RE: FLOOD IMPACT AND RISK ASSSESSMENT FOR 893 PATERSON RD WOODVILLE

Torrent Consulting was engaged to undertake a Flood Impact and Risk Assessment to assist in the planning and approval process for the proposed 'Gracemere' Function Centre at 893 Paterson Road (Lot 10 DP 1035397), Woodville, NSW (the Site). The development proposal is for the construction of a function venue to accommodate up to 180 guests together with kitchen and toilet facilities. Provision would also be made for a car parking area catering for around 56 vehicles.

Response to SES Comments

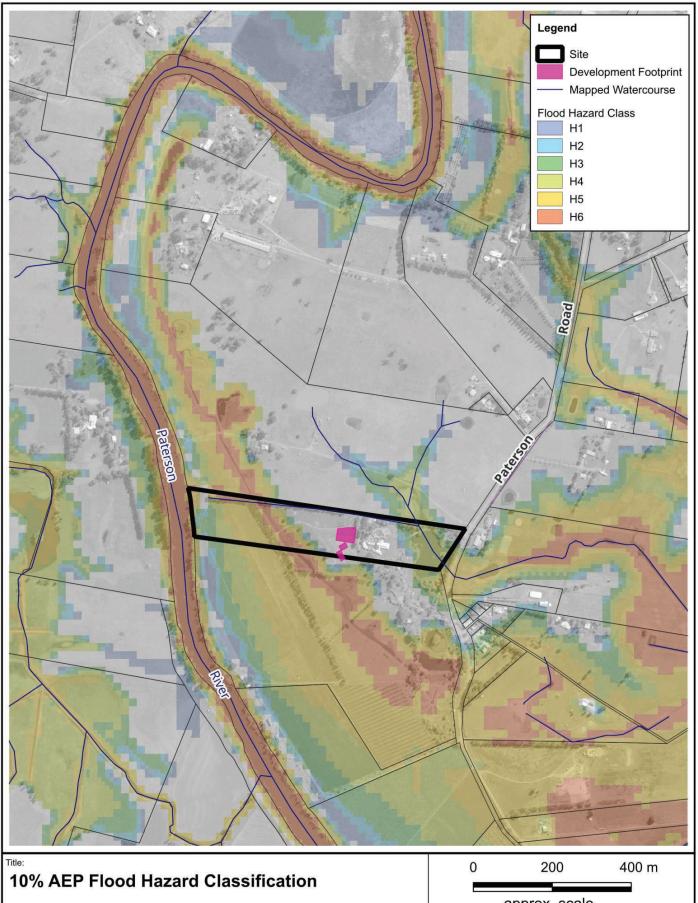
Note the site is a high flood island, isolated by floodwaters of 1 metre depth and H5 flood hazard level
in the 10% AEP riverine flooding events, suggesting isolation is likely to occur in more frequent
events

Response: The 10% AEP event on the Paterson River is representative of the condition that initiates site isolation. The levee along the river alignment in the reach adjacent to the Site has approximate crest levels between 7.0 - 7.5m AHD. The simulated peak flood level in the river at this location for the 10% AEP event

is ~7.1m AHD which provides for overtopping in this reach and subsequent Site inundation. The corresponding 20% AEP flood level for the river is ~6.6m AHD providing some additional freeboard to the overtopping level. Accordingly, whilst Site inundation may be initiated between the 20% AEP and 10% AEP events, it is much closer to the 10% AEP magnitude which may be considered as the representative design flood immunity for the Site.

PMF Flood Hazard Classification - Site Detail

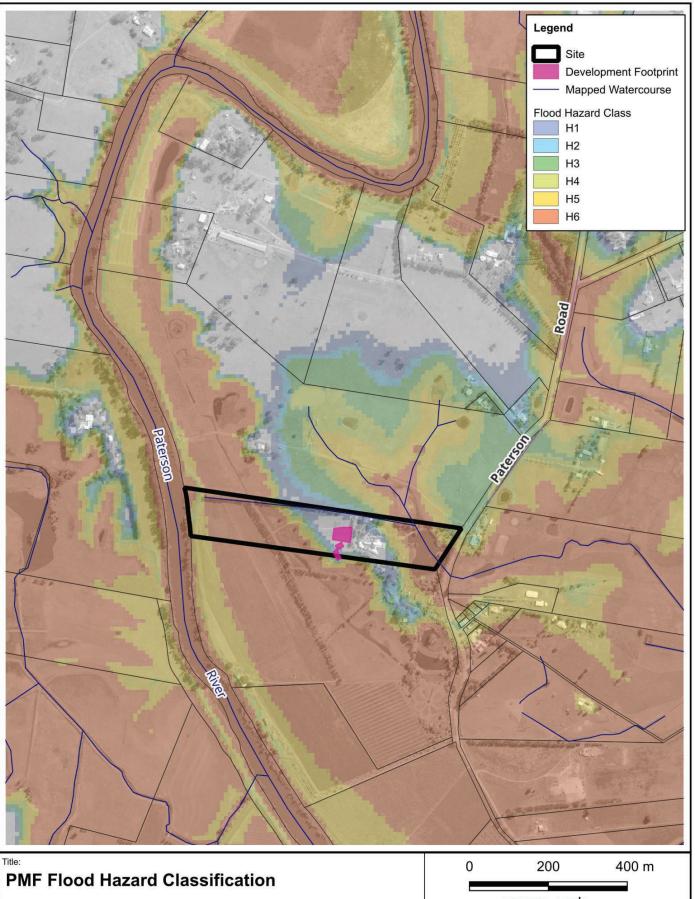
- Recommend the FIRA include:
 - flood depth, velocity and hydraulic hazard for the full range of modelled events, up to and including the PMF. Noting isolation is likely to occur before the 10% AEP riverine flooding events, we recommend more frequent events are assessed, to understand when the site first becomes isolated.

Response: Additional mapping is superfluous to understanding the flood risk context for the Site. The proposed buildings are shown to be only subject to extreme events with only partial inundation or H1-H2 hazard category at the PMF (refer to Figure 13). The Site isolation has been confirmed to be at the approximate 10% AEP probability (as opposed to closer to 20% AEP) with the 10% AEP flood hazard classifications shown in Figure 10 confirming loss of flood access. For reference, the 20% AEP flood inundation extent and flood depth distribution is shown in Figure 15.

Modelled 20% AEP Flood Depth and Inundation Extent

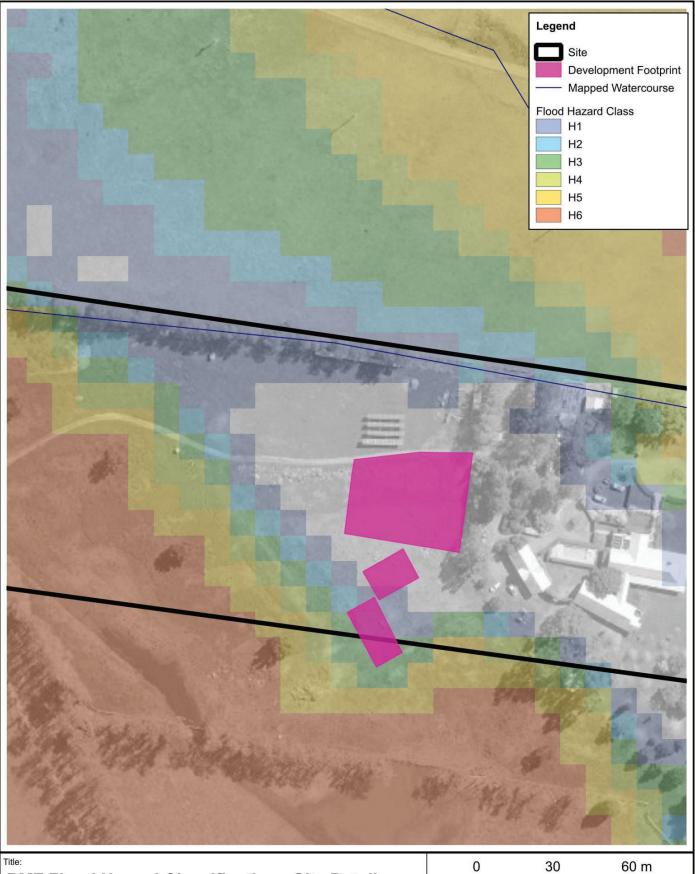
- Recommend the FIRA include:
 - modelling of post-development flooding conditions for the full range of events.

Response: As noted, the proposed building footprints have limited interaction with existing design flood extents with the PMF mapping showing only partial encroachment into low hazard flood conditions and accordingly have no impact on existing flood conditions. Accordingly, post-development modelling of the design proposal has no functional value to the risk assessment.
